E3980A-FG-01

# Modification Recommended Service Note

## E3980A-FG SimPlate Fixture Alignment Plates, Standard, Pack of 10

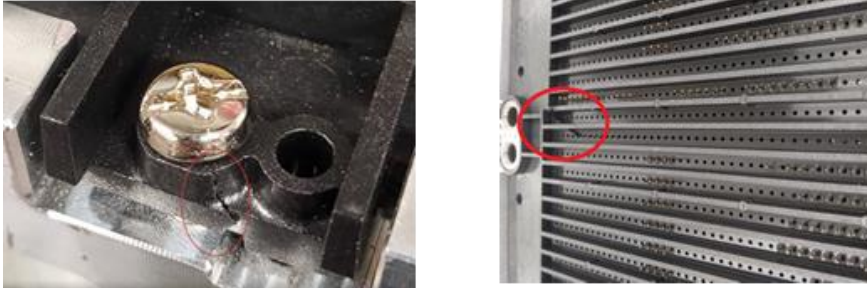
E3980A-FG (SimPlate Fixture Alignment Plates) are used in test fixtures in i3070 test systems. For certain batch, cracks are found near screw hole and other areas after use.

Some users have reported that after assembling E3980A-FG into the fixture, cracks started to show up after short period of usage, as shown in the pictures below.

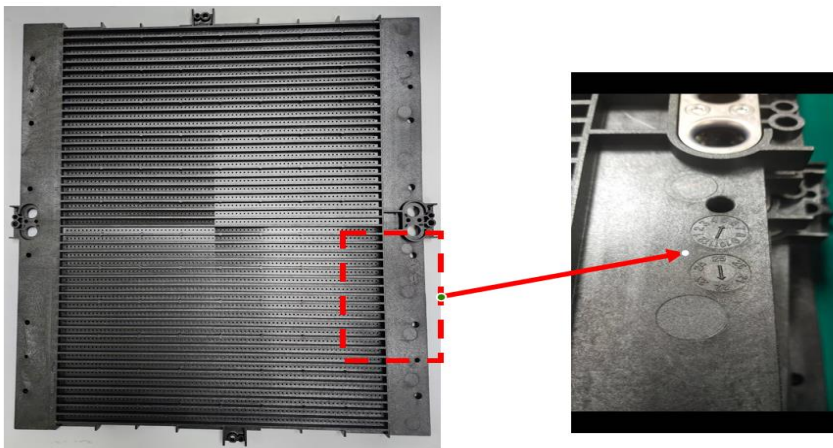
Factory has screened all the stocks on hand and identified that manufacture process has been compromised for certain batch of alignment plates.

The affected batch can be identified by the date code of “05/22” engraved on the bottom of plates as shown on the picture below.

Keysight will provide one to one exchange at no cost to the affected customers if the data code is 05/22 for E3980A-FG product. Please contact local Keysight sales and support organization to arrange for the replacement.
